UNITED STATES PATENT AND TRADEMARK OFFICE

| APPLICATION NO. | FILING DATE | FIRST NAMED INVENTOR | ATTORNEY DOCKET NO. | CONFIRMATION NO. |
|-----------------|-------------|----------------------|---------------------|------------------|
| 10/698,266 | 10/31/2003 | Leo Wenstrup | 1-16404 | 1672 |

Office Action Summary

Fig. 3

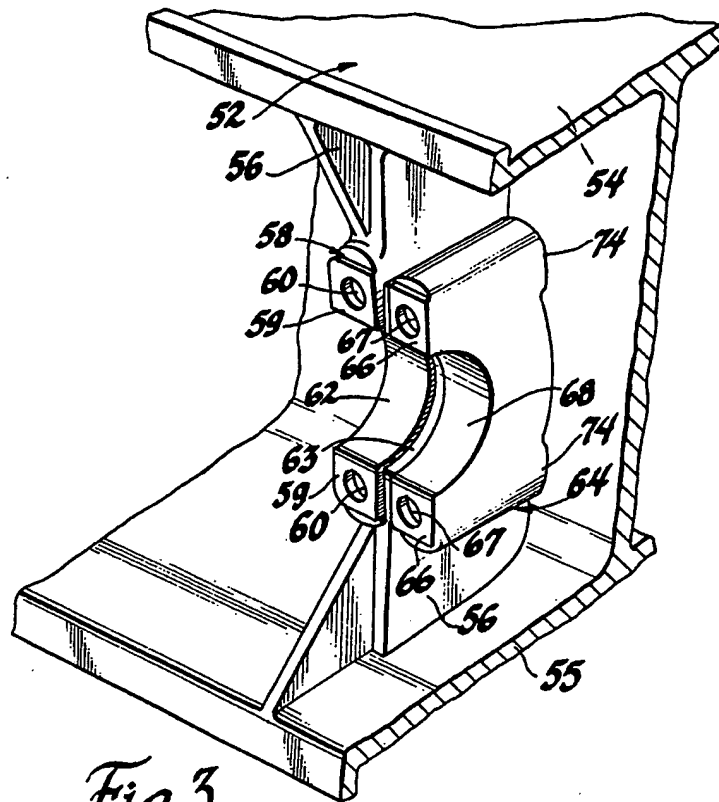
Regarding claim 3, each end (at 60 in Fig. 3) of said pilot web 56 comprises two apertures 60, and said differential carrier (not shown in Fig. 3) comprises four apertures in complementary positions to said apertures 60 of said pilot web 56. *Ibid.* col. 2, line 47 through col. 3, line 58, and claims 1-3.

Regarding claim 4, the pilot web and differential carrier assembly of the embodiment of Fig. 3 comprises four bolts disposed through said complementary apertures 60 and 67 of said pilot web 56 and said differential carrier 64. *Ibid.* col. 2, line 47 through col. 3, line 58, and claims 1-3.

Regarding claim 5, the pilot web and differential carrier assembly of the embodiment of Fig. 3 comprises four bushings 71, each of said bushings 71 being disposed about a corresponding one of said bolts 70. *Ibid.* col. 2, line 47 through col. 3, line 58, and claims 1-3.

Regarding claim 3, each end (at 60 in Fig. 3) of Arnold's pilot web 56 comprises two apertures 60, and Arnold's differential carrier or the like (not shown in Fig. 3) comprises four apertures in complementary positions to said apertures 60 of said pilot web 56. *Ibid.* col. 2, line 47 through col. 3, line 58, and claims 1-3.

Regarding claim 4, the pilot web and differential carrier assembly of the embodiment of Fig. 3 of Arnold comprises four bolts disposed through said complementary apertures 60 and 67

Regarding claim 5, the pilot web and differential carrier assembly of the embodiment of Fig. 3 of Arnold comprises four bushings 71, each of said bushings 71 is disposed about a corresponding one of said bolts 70. *Ibid.* col. 2, line 47 through col. 3, line 58, and claims 1-3.

Fig. 4

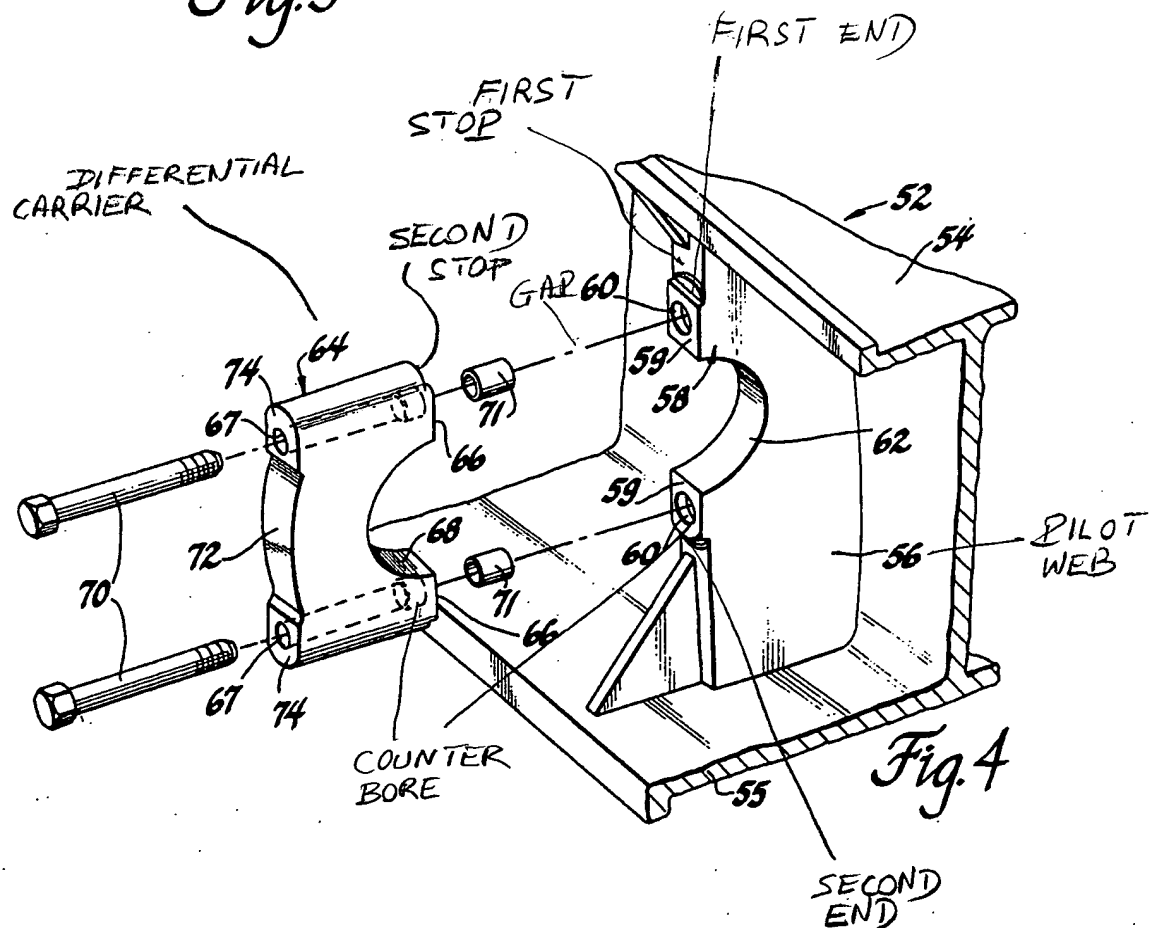
a first stop (Att., Fig. 4) on said pilot web 56;

a second stop (Att, Fig. 4) on said differential carrier 64, said second stop (Att.) being disposed adjacent to, and aligned with, said first stop (Att.), wherein said first and second stops (Att.) define a gap there between;

Regarding claim 2, each end (at 60 in Fig. 4) of said pilot web 56 comprises a single aperture 60, and said differential carrier 64 comprises two apertures 67 in complementary locations to said apertures 60 of said pilot web 56.

Regarding claim 6, the pilot web and differential carrier assembly of the embodiment of Fig. 4 comprises two bushings 71, one of said bushings 71 is disposed about a corresponding one of said bolts 70 at said first end (Att.) of said pilot web 56, and the other of said bushing 71 is disposed about a corresponding one of said bolts 70 at said second end (Att.) of said pilot web 56. See col. 4, line 61 through col. 5, line 3.

Regarding claim 7, each of said apertures 60 in said pilot web 56 and each of said apertures 67 in said differential carrier 64 which correspond to one of said bushings 71 is counter bored (Att., Fig. 4) to receive the bushing 71. *Ibid.* col. 2, line 47 through col. 3, line 6.

Regarding claim 2, each end (at 60 in Fig. 4) of Arnold's pilot web 56 comprises a single aperture 60, and Arnold's differential carrier or the like 64 comprises two apertures 67 in complementary locations to said apertures 60 of said pilot web 56.

Regarding claim 6, the pilot web and differential carrier assembly of the embodiment of Fig. 4 of Arnold comprises two bushings 71, one of said bushings 71 is disposed about a corresponding one of said bolts 70 at said first end (Att.) of said pilot web 56, and the other of said bushing 71 is disposed about a corresponding one of said bolts 70 at said second end (Att.) of said pilot web 56. See col. 4, line 61 through col. 5, line 3.

Regarding claim 7, each of Arnold's apertures 60 in said pilot web 56 and each of Arnold's apertures 67 in said differential carrier or the like 64 which correspond to one of said bushings 71 is counter bored (Att., Fig. 4) to receive the bushing 71. *Ibid.* col. 2, line 47 through col. 3, line 6.
